Project	<b>IEEE 802.16 Broadband Wireless Access Working Group</b> < <a href="http://ieee802.org/16">http://ieee802.org/16</a> >	
Title	<b>STC Enhancements for optional FUSC and AMC zones for OFDMA PHY Layer</b>	
Date Submitted	<b>2004-05-19</b>	
Source(s)	<p>Wonil Roh, Seungjoo Maeng, Jiho Jang, Panyuh Joo, Jaeho Jeon, Soonyoung Yoon</p> <p>Samsung Electronics Co., Ltd.</p> <p>Peiying Zhu, Wen Tong</p> <p>Nortel Networks</p> <p>Yossi Segal</p> <p>Runcom</p>	<p><a href="mailto:wonil.roh@samsung.com">wonil.roh@samsung.com</a></p> <p>Voice: +82-31-279-3868</p>
Re:	In response to Comment #232 as a reply comment	
Abstract	STC enhancements for the optional AMC and FUSC for the downlink	
Purpose	Adoption of proposed changes into P802.16e	
Notice	This document has been prepared to assist IEEE 802.16. It is offered as a basis for discussion and is not binding on the contributing individual(s) or organization(s). The material in this document is subject to change in form and content after further study. The contributor(s) reserve(s) the right to add, amend or withdraw material contained herein.

# STC Enhancements for Optional FUSC and AMC Zones for OFDMA PHY Layer

**Figure vvy-1 Pilot allocation for 2-antenna BS for the optional FUSC and the optional AMC zones**

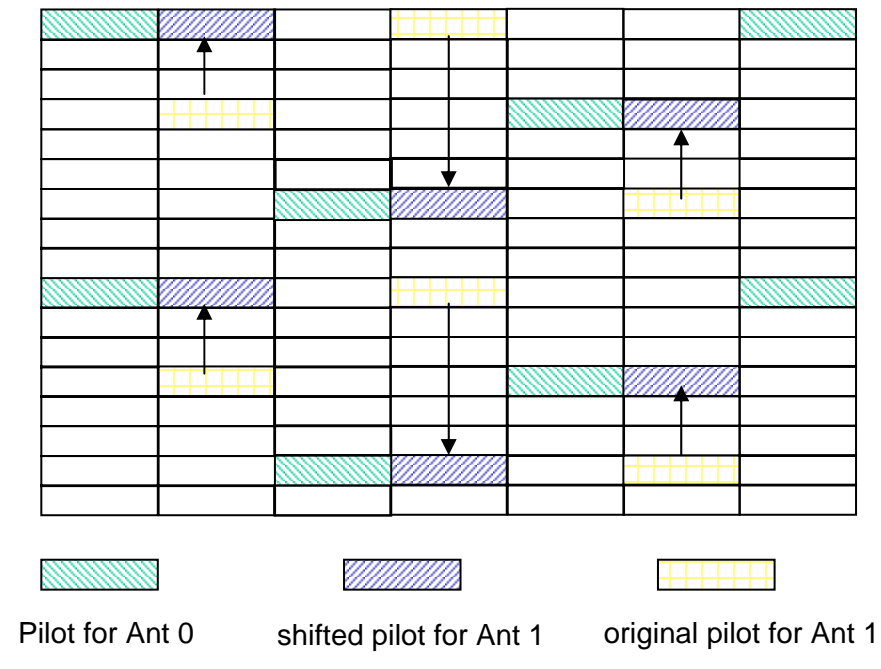
For 2-antenna BS, all pilots in the even symbols shall be allocated for antenna 0 whereas all pilots in the odd symbols shall be allocated for antenna 1. The positions of pilots in the odd symbols are further switched with those of data subcarriers whose locations coincide with pilots in the previous symbol. This is shown in Figure yyy-1.

**Figure vvy-2 Pilot allocation for 4-antenna BS for the optional FUSC and the optional AMC zones**

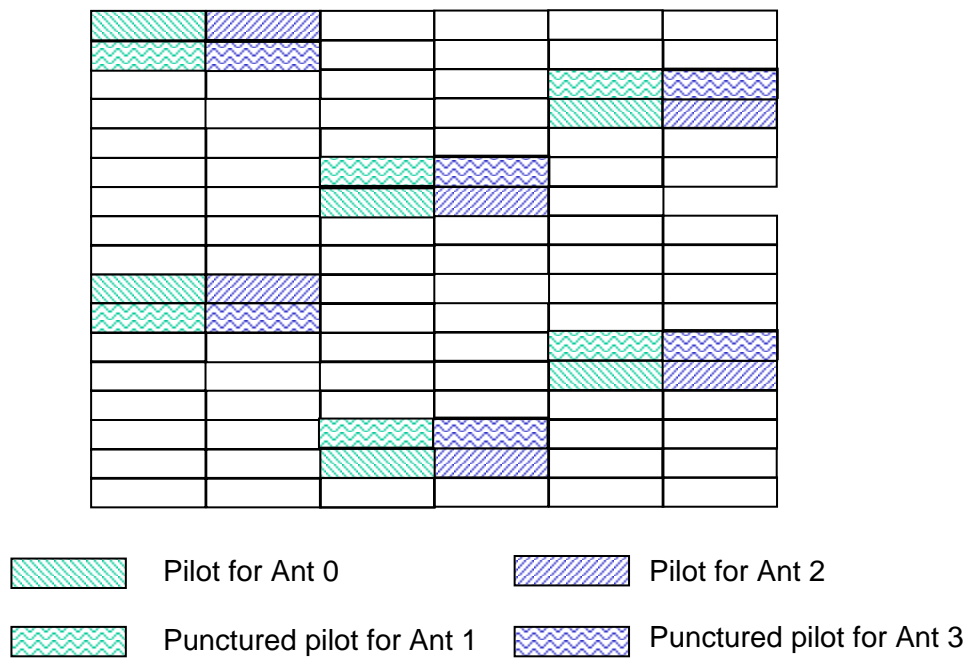
For 4-antenna BS, pilot pattern shall first be changed as in the 2-antenna BS case, and then the neighboring two subcarriers shall be further punctured for antenna 2 and 3 as is shown in Figure yyy-2.
